**STAFF REPORT  
KETCHUM PLANNING AND ZONING COMMISSION  
REGULAR MEETING OF JULY 11, 2023**

**PROJECT:** Pratt Residence

**FILE NUMBER:** P23-009 and P23-009A

**APPLICATION TYPE:** Mountain Overlay Design Review and Conditional Use Permit

**A200B**  
ARCHITECTURAL SITE PLAN

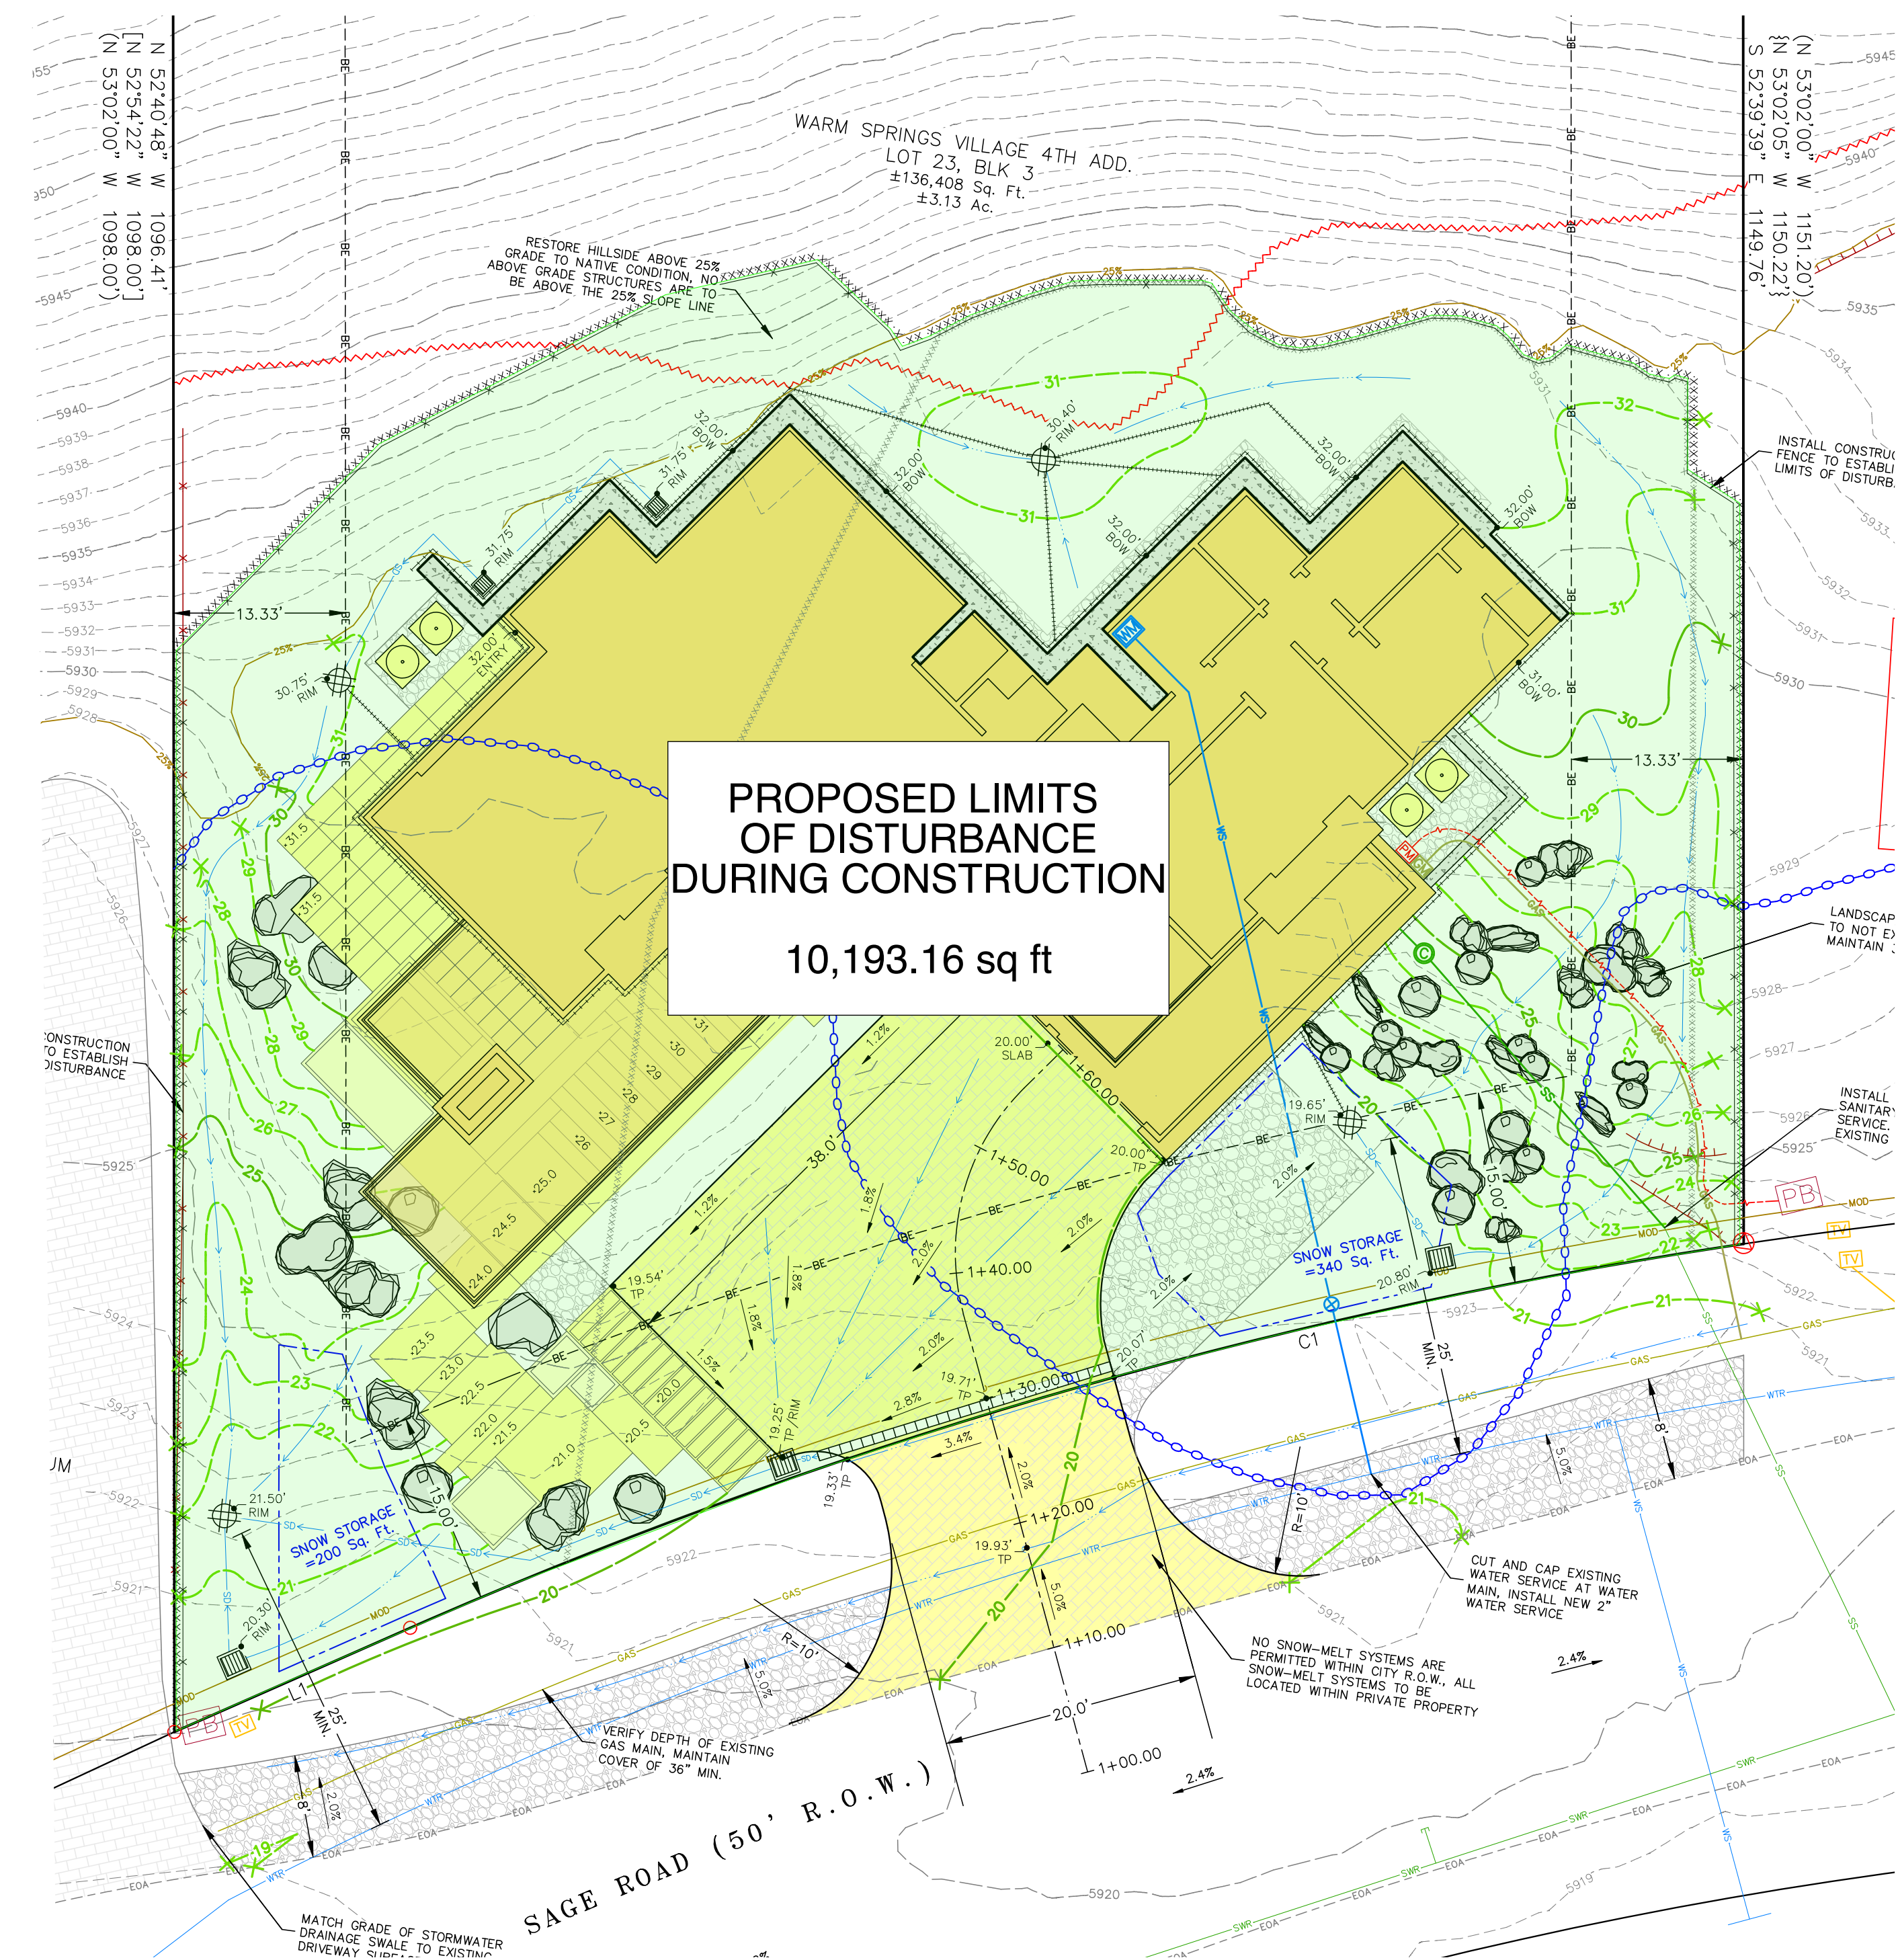
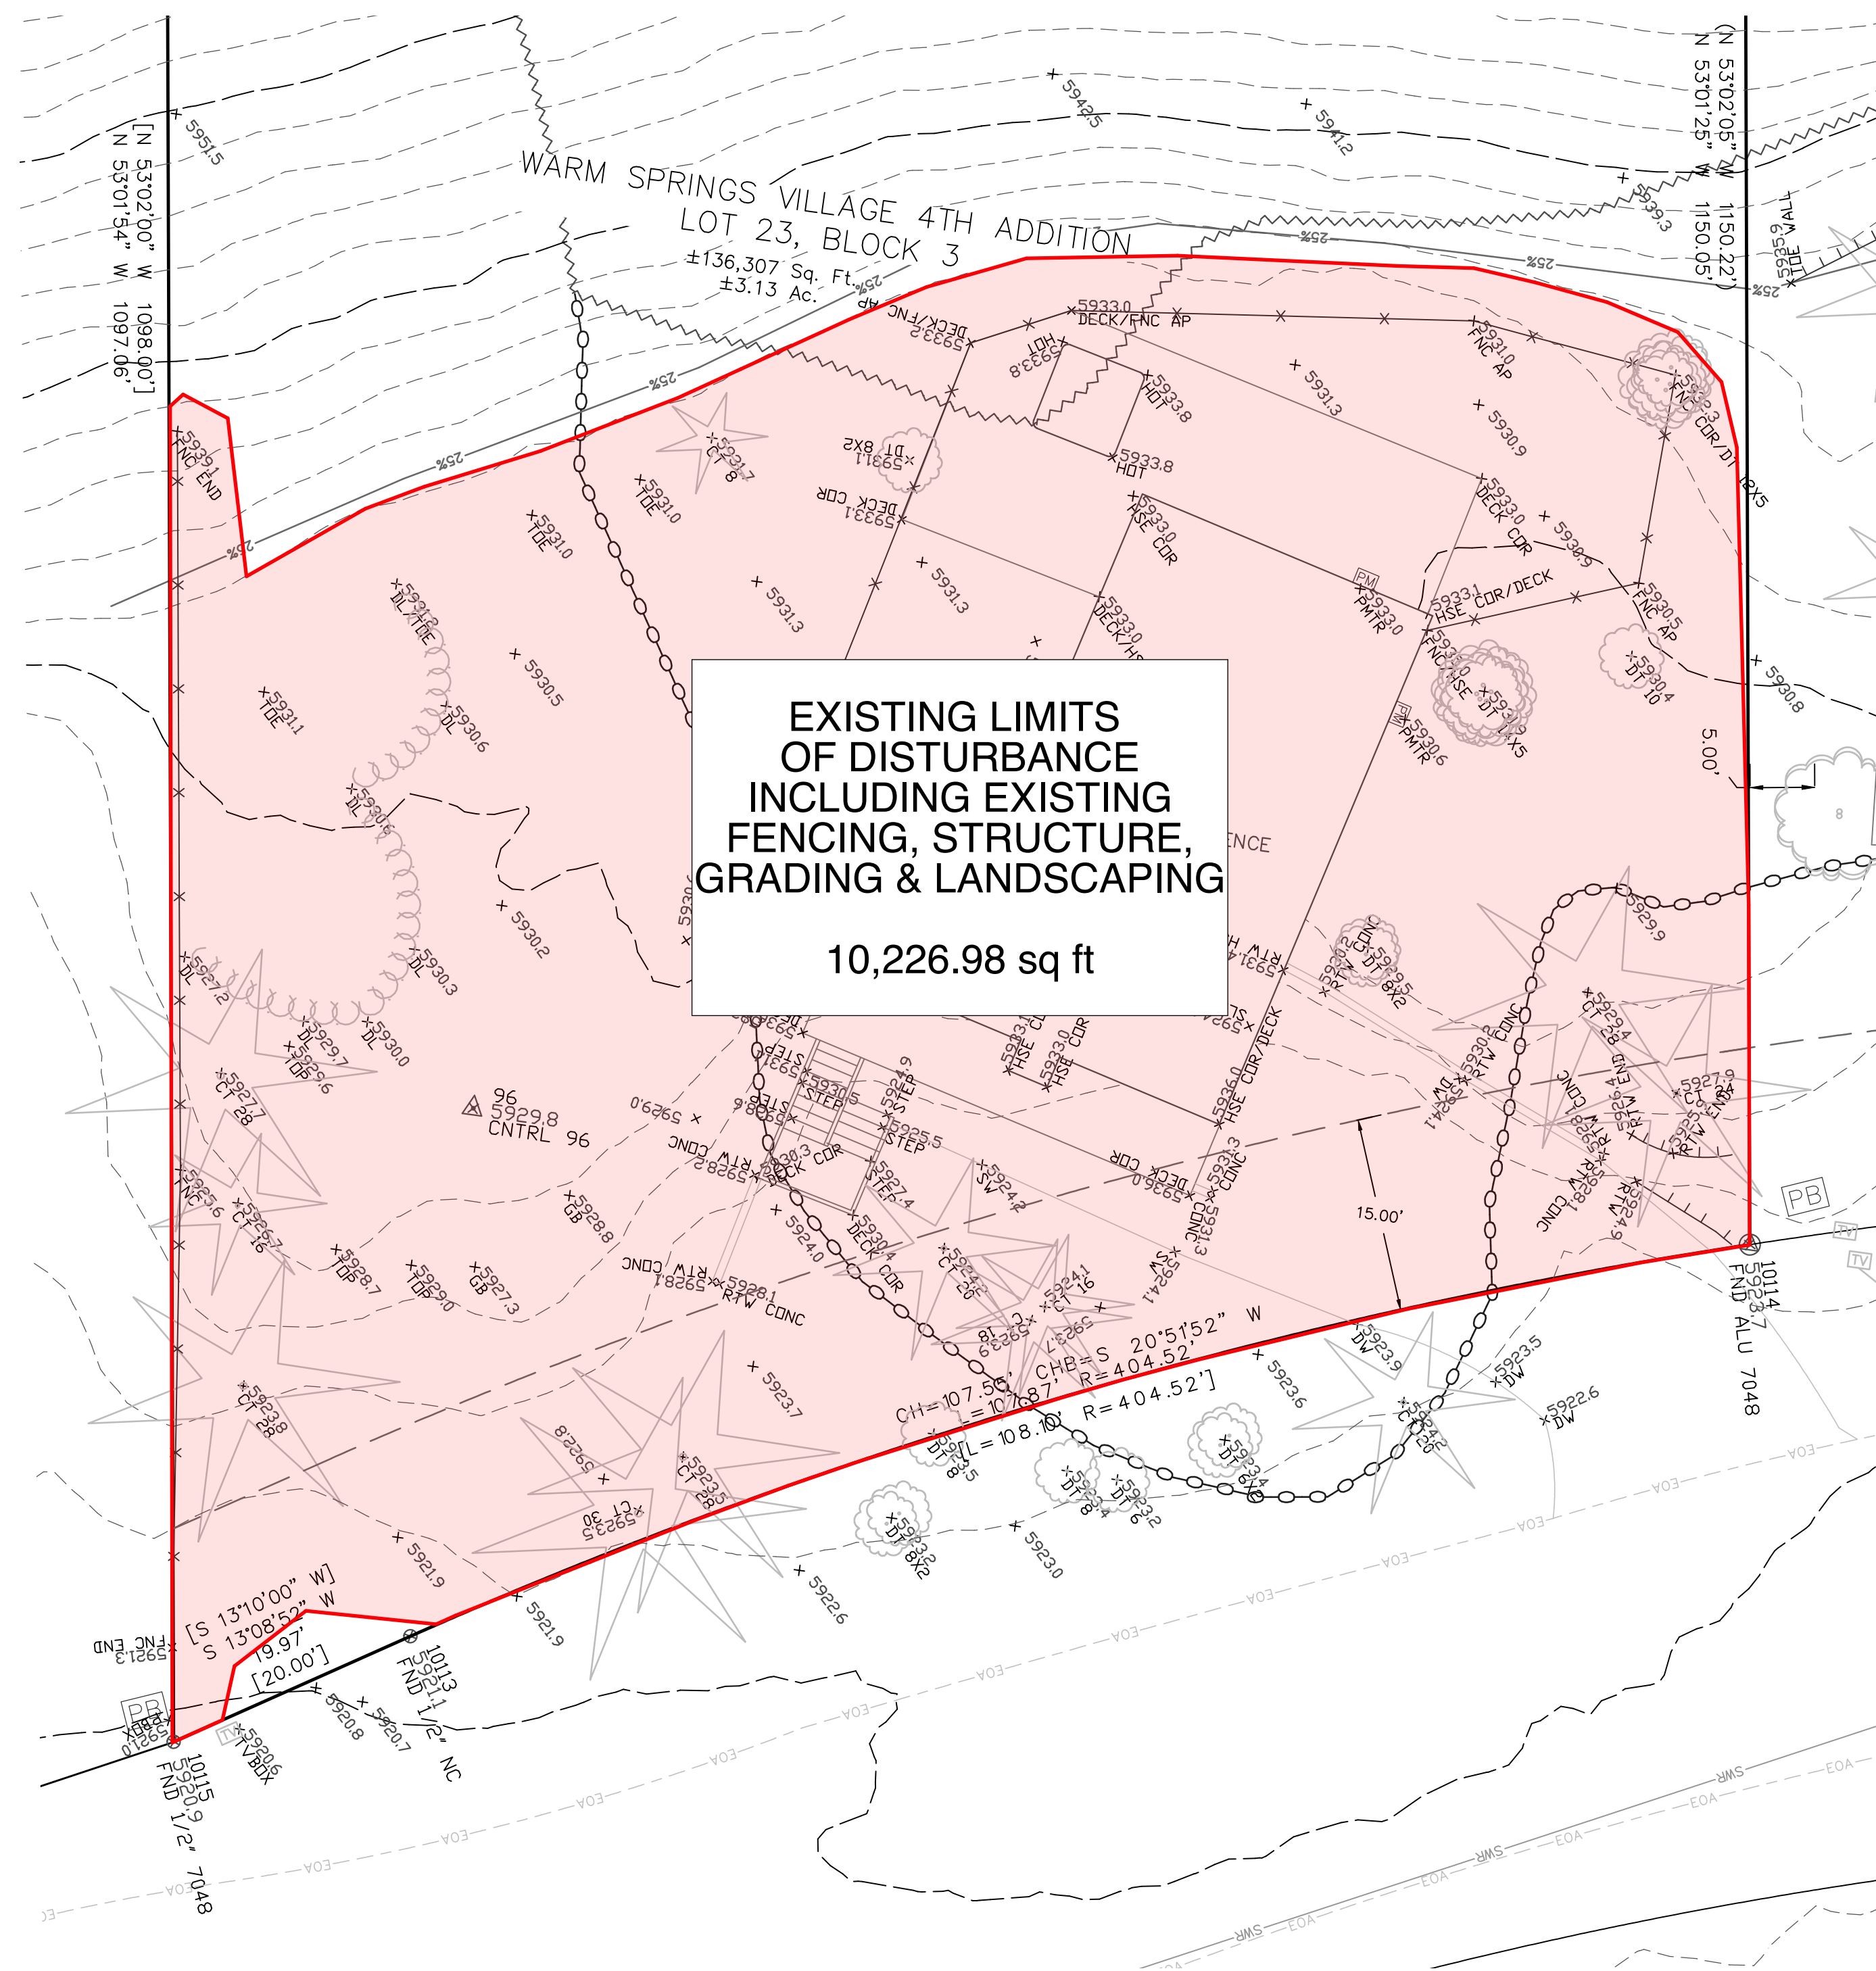
encroach into the 25% slope area. However, 396 square feet of disturbance into the hillside is proposed for the structure's construction. This disturbance is not reflected in the current plan set, as staff had brought it to the applicant's attention that the existing limits of disturbance diagram on Sheet A200C of Attachment B had not accurately reflected the site survey. The applicant informed staff that an outdated site survey had been used and sent staff a revised Sheet A200C which increased the proposed limits of disturbance from 254 square feet to 396 square feet. The MOD does encourage development to be sited down on the hillside, which the proposed residence does by having just slightly above the minimum required front yard setback. However, as the development uses more of the western portion of the lot, the development does see encroachment into the 25% slope area. In previous Mountain Overlay applications, the Commission has been supportive of minor encroachments into the 25% slope area for permanent structures. The project is proposing temporary encroachment into the 25% slope for construction that would be reclaimed following completion of the project. Therefore, staff is supportive of the proposed temporary encroachment into the hillside.
